LAND USE APPLICATION SUMMARY

Property Location: 5517 Lyndale Avenue S
Project Name: Mount Olivet Careview Home Addition
Prepared By: Kimberly Holien, Senior City Planner, (612) 673-2402
Applicant: Tim Hokanson, Mount Olivet Careview Home
Project Contact: Dave Wolterstroff, WAI Continuum
Request: To construct a 36,184 square foot addition to an existing board and care home/assisted living facility.

1 ARCHITECTURAL SITE PLAN
A1.0 SCALE: 1"=30'-0"
SCALE: 1"=60'-0"

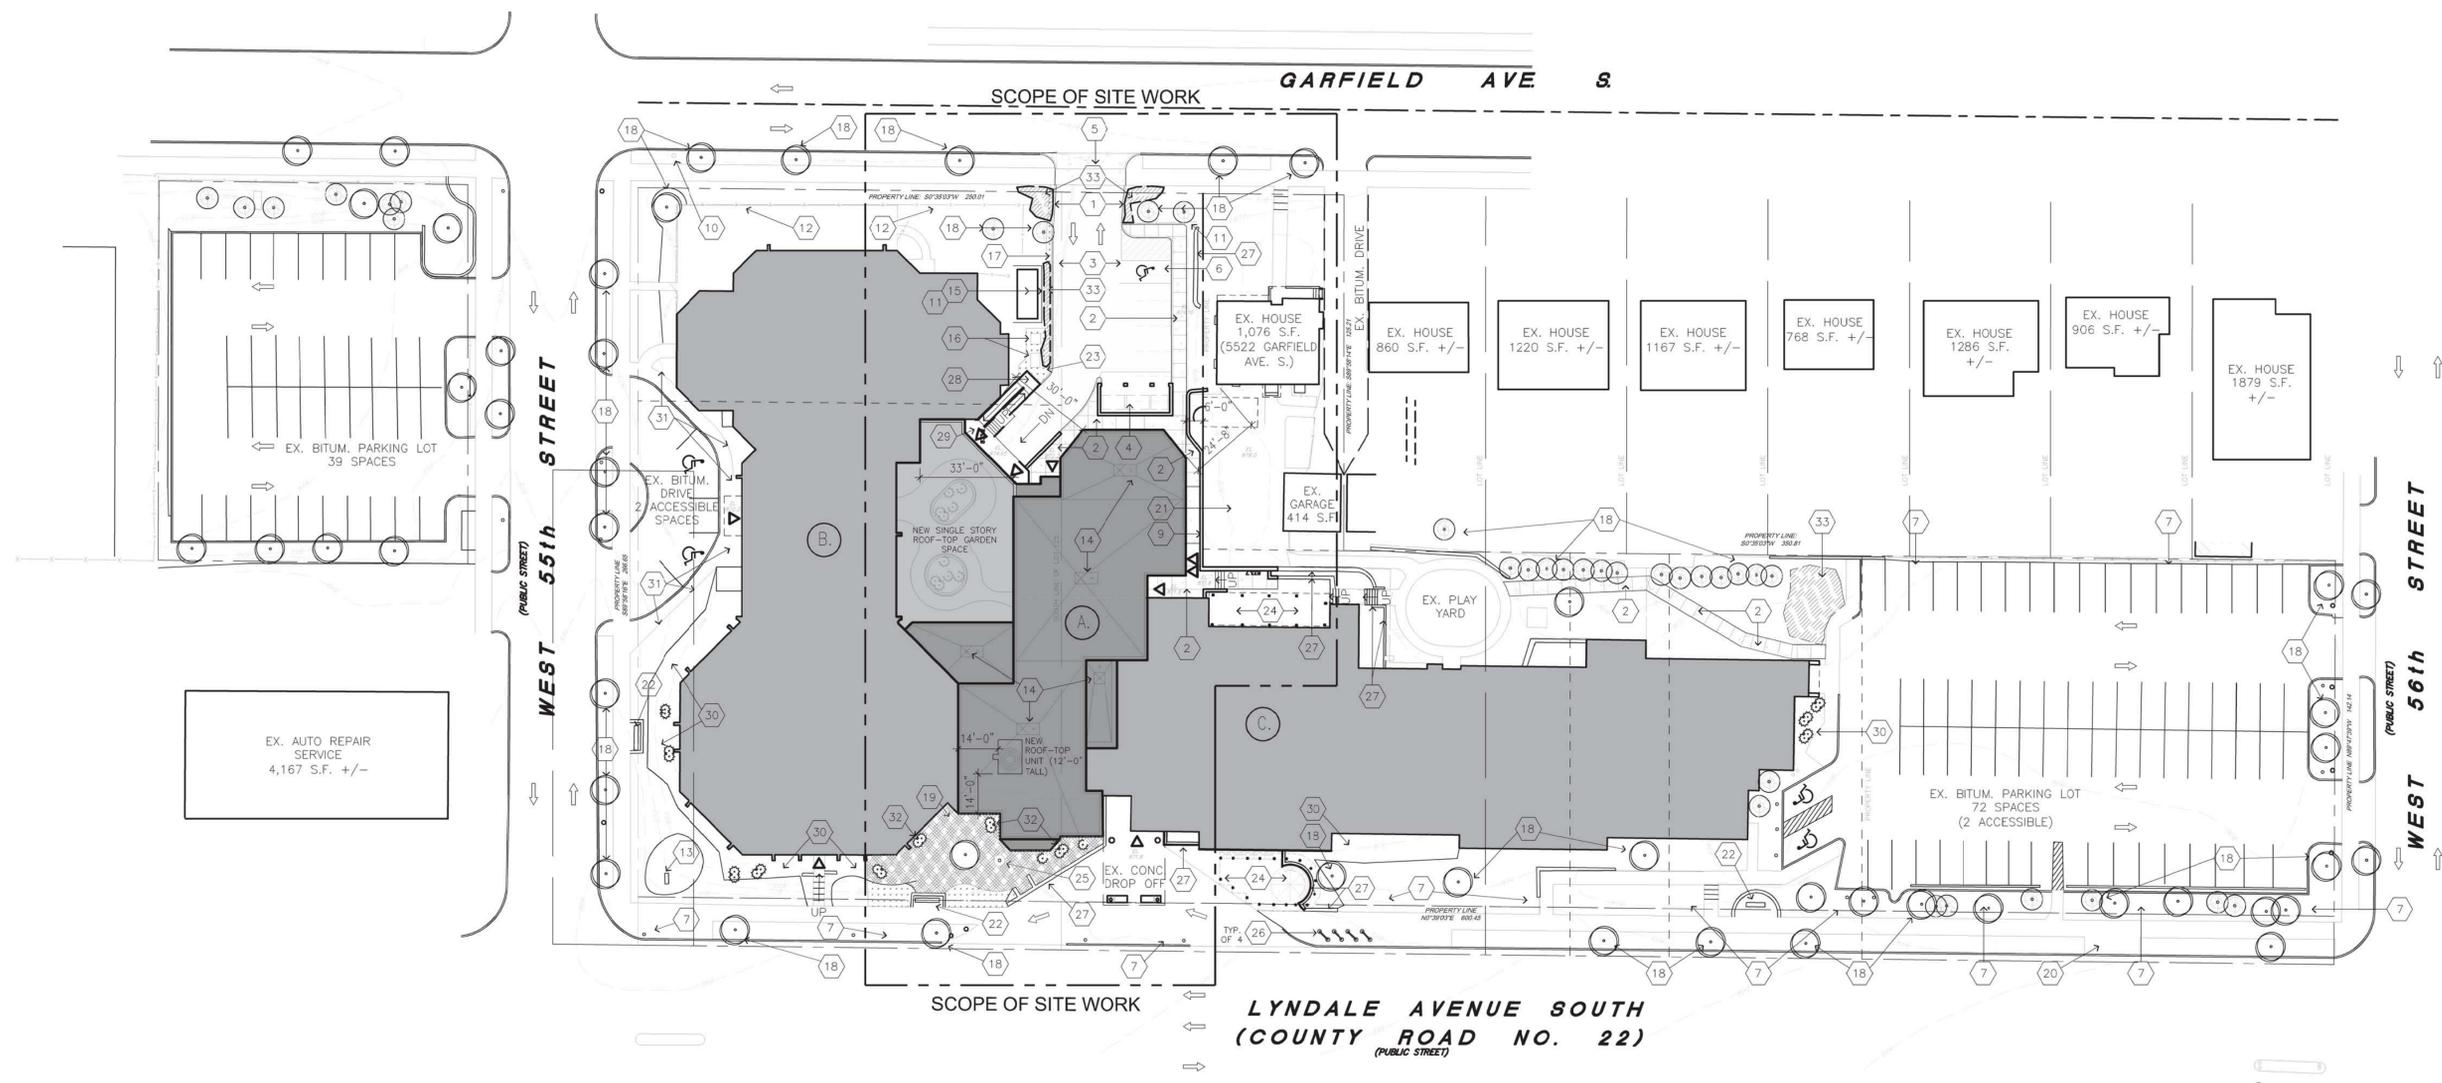
- The site plan exceeds the total amount of green space and the required number of trees, per Table 3 below. Alternative compliance is requested for the shrub requirement.

- Parking and loading facilities along public and where adjacent to residential uses require landscaped yards a minimum of seven feet in width with screening that is a minimum of 60 percent opaque and three feet in height along the street and 95 percent opaque and six feet in height adjacent to residential. The required landscaped yards are provided along all public streets adjacent to the south parking lot. The required screening is shown on the landscaping plan. However, the landscaping shown on the plan was also proposed as part of the variance application per BZZ-6585. Zoning Enforcement staff recently inspected the site and found that it was not in compliance with the approved landscape plan. In order to come into compliance with the plan, the following is required:

- 3 coniferous shrubs on the west side of the two parking stalls in the southwest corner of the parking lot
- The parking area in the south portion of the site also abuts residential uses to the east. There is no landscaped yard in this location but there is a solid wood fence. Said fence was approved in lieu of the landscaped yards in previous site plan review applications.

5. A minimum of seventeen additional shrubs shall be planted in the landscaped yard between the addition and Lyndale Avenue S for an overall site total of 118 shrubs, in compliance with Section 530.110 and Section 530.160 of the zoning code.

6. The landscaped yard between the east parking area and Garfield Avenue S shall contain plantings that are a minimum of three feet in height and 60 percent opaque for the length of the yard, in compliance with Section 530.170 of the zoning code.

1 SOUTH ELEVATION
SCALE: 1/8" = 1'-0" @ 24"x36"

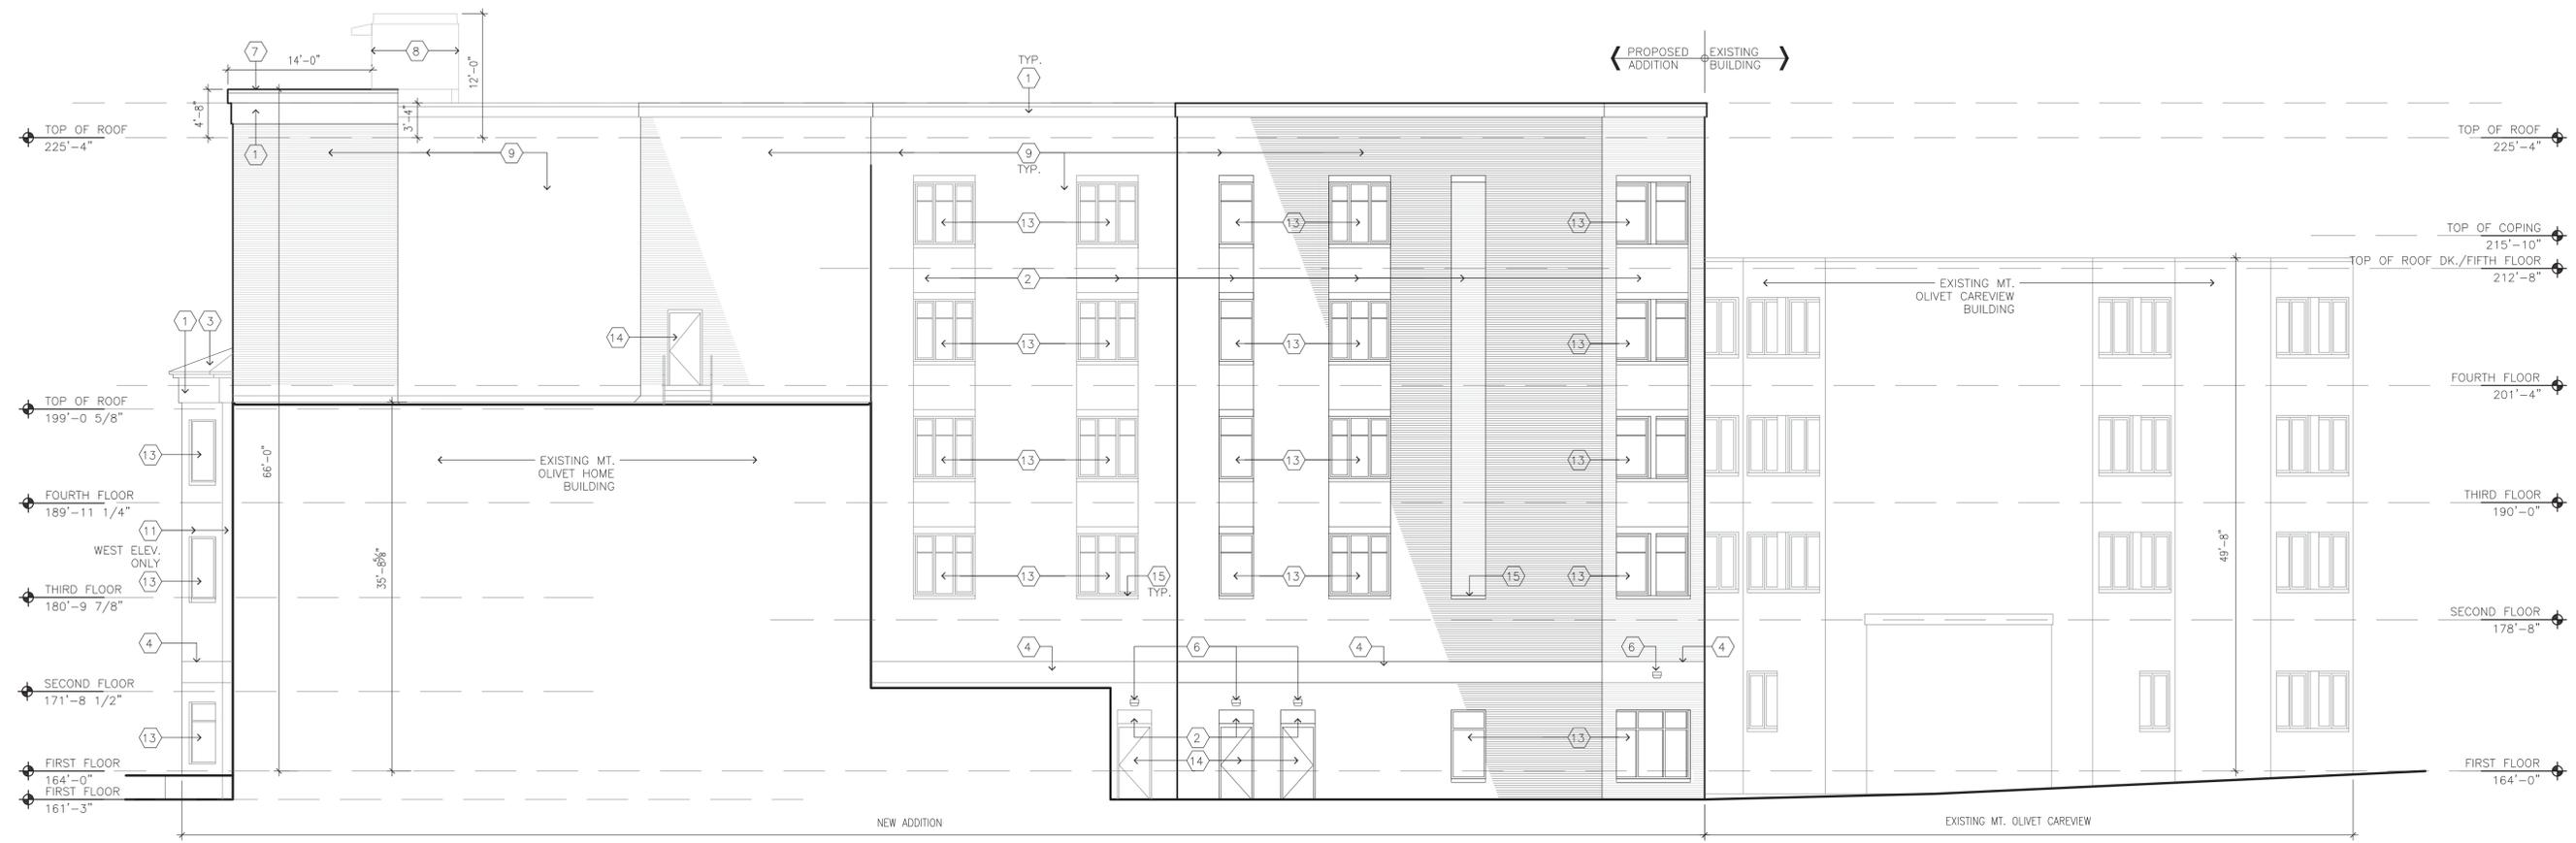
- **Even distribution of windows.** Windows on the east elevation are not evenly distributed. The center of the east elevation contains no windows. Staff does not recommend granting alternative compliance. This section of the building also requires alternative compliance for blank walls. As a condition of approval, staff will be recommending that windows are added to this section of blank wall.

2. CPED Staff shall review and approve the final site, elevation, landscaping and lighting plans before building permits may be issued.
3. Windows shall be provided on the east elevation to reduce the length of the blank wall and provide for even distribution of windows, in compliance with Section 530.120 of the zoning code.

4. The arches above the windows on the fifth floor of the west elevation shall be removed to provide for even distribution, in compliance with Section 530.120 of the zoning code.
